SAFETY EVALUATION BY THE OFFICE OF NUCLEAR REACTOR REGULATION
REQUESTS FOR RELIEF FROM ASME CODE SECTION XI
EXAMINATION REQUIREMENTS FOR REACTOR
COOLANT PUMP CASING WELDS AND
INTERNAL SURFACES

SACRAMENTO MUNICIPAL UTILITY DISTRICT
RANCHO SECO NUCLEAR GENERATING STATION
DOCKET NO. 50-312

RCP ILLUSTRATION

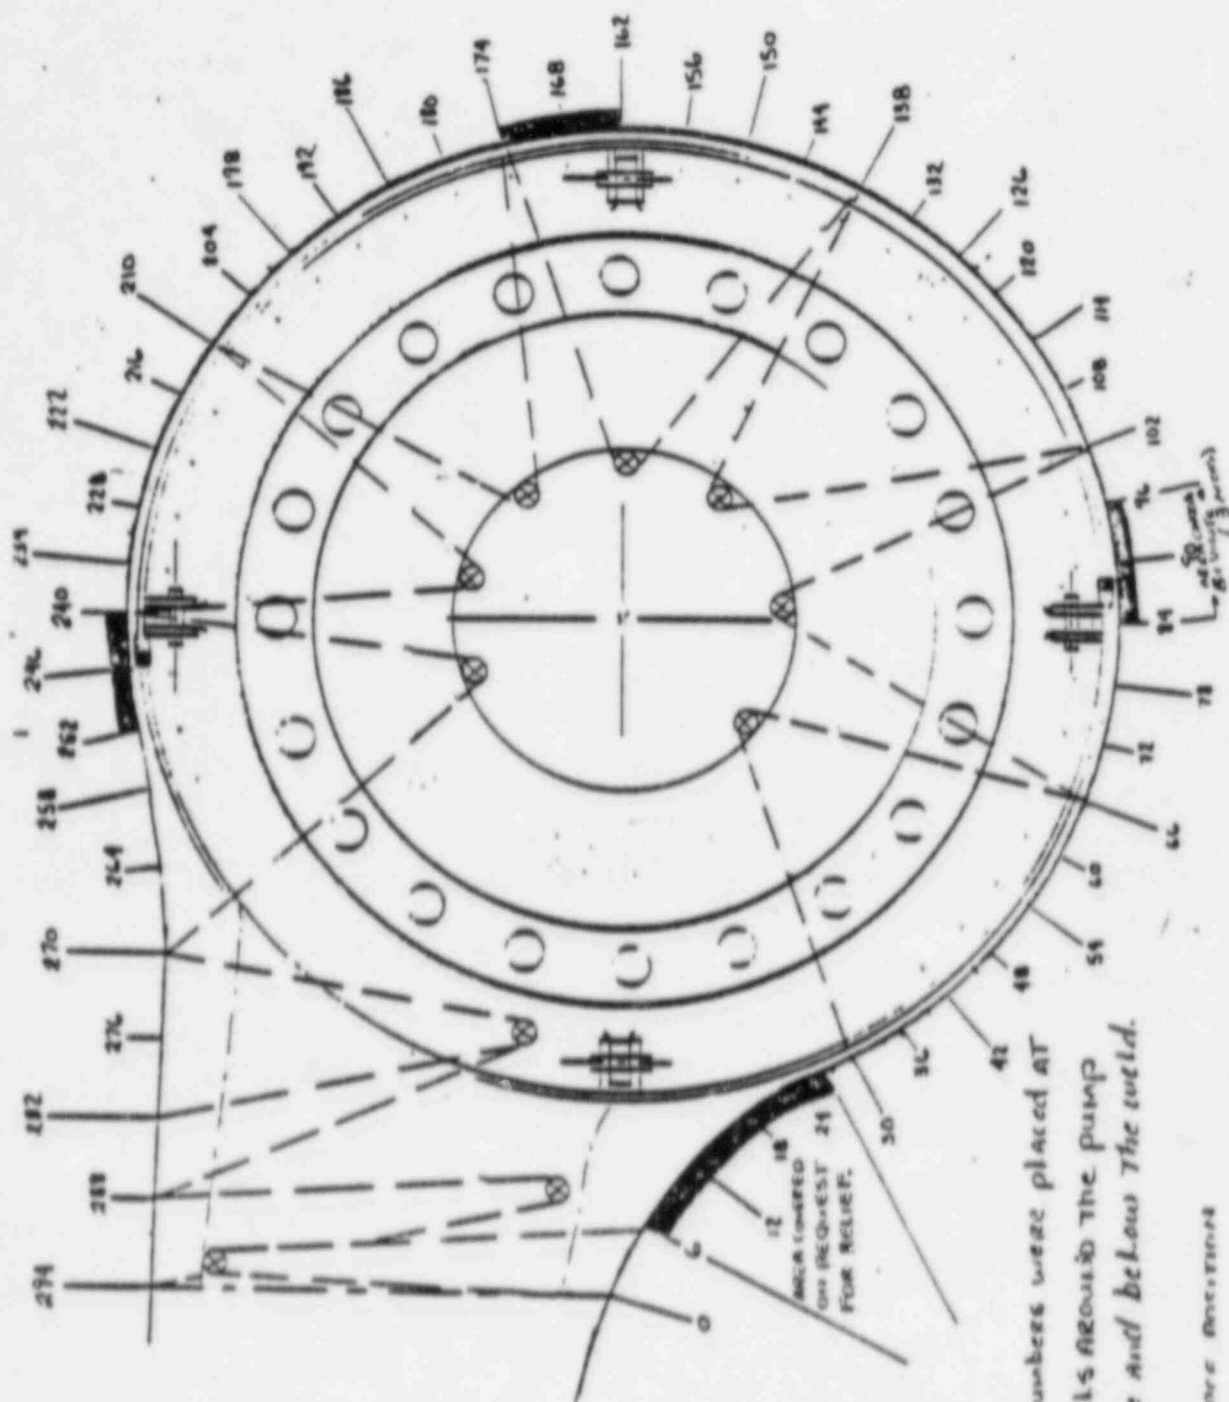
The Reactor Coolant Pumps were designed and manufactured by Bingham-Willamette Company before Section XI of the ASME Boiler and Pressure Vessel Code was developed. The pump casing was designed in such a way that a large portion of the internal pressure boundary is inaccessible for visual inspection, and small areas at the outer edges of the volute are inaccessible for volumetric inspection using radiography. The area on the inside radius of the discharge nozzle is too thick (.14") to inspect with any available technique. The geometry of the pump casing and the internal volute also make it impractical to achieve the 1T base metal coverage specified by Table 1WB 2500 of the 1974 Section XI with Summer '75 Addenda. The pump casing is composed of cast stainless steel. Ultrasonic inspection is impractical due to the large grain size and high attenuation. Therefore, the Code as it presently stands does not give adequate consideration to pumps that were designed in this manner. These areas can be seen on the attached illustration. A visual inspection of the areas above the internal volute would require cutting the pump casing open.

The remaining portion of the casing can be visually and volumetrically inspected and the results of this portion of the inspection should be indicative of the conditions that may exist in the inaccessible areas. The area covered by the volumetric inspection will be as shown in figure 1WB-2500-16 of the 1980 Edition of ASME Section XI, except in the areas covered by the volute (estimated to be less than 7% of the area of interest) and the inside radius of the discharge nozzle (approximately 5% of the area of interest). The visual inspection will cover those areas accessible through the four volute openings.

Lead numbers were placed at 6° intervals around the pump 2.5" above and below the weld.

The Code requirements to perform (1) volumetric examination of 100% of the pressure-retaining pump casing weld, (2) visual examination of 100% of the internal pressure boundary surfaces, and (3) volumetric examination of the base metal for one wall thickness beyond the edge of the weld are impractical to perform on the reactor coolant pumps at Rancho Seco because of the pumps' design. The internal volute prevents access for performing 100% volumetric examination of the pump casing weld and 100% visual inspection of the internal surfaces. The base metal thickness of the pump casing (which can typically vary from 8 inches to 14 inches) makes the requirement to examine one wall thickness beyond the edge of the weld an impractical requirement.

We have reviewed the Code requirements as applicable to the Rancho Seco reactor coolant pump examinations. The licensee stated in the letter of March 5, 1985, that the area subject to examination but covered by the pump volute is less than 7% and that in the area of the discharge nozzle approximately 5%. The requirement to examine the base metal one wall thickness beyond the edge of the weld was changed in later editions of the Code in recognition that the heat affected zone does not extend one wall thickness in relatively thick components. The requirement was changed to 1/2-inch beyond the edge of the weld as shown in IWB-2500-16 of the 1980 Edition of Section XI and as proposed to be examined by the licensee.

We conclude that the licensee's proposed alternative examinations of the reactor coolant pumps at Rancho Seco will provide the necessary assurance of the pumps' structural integrity and that relief from the requirements, as requested, may be granted. We conclude, based on the considerations discussed above, that the granting of this relief is authorized by law and will not endanger life or property or the common defense and security and is otherwise in the public interest giving due consideration to the burden upon the licensee that could result if the requirements were imposed on the facility.
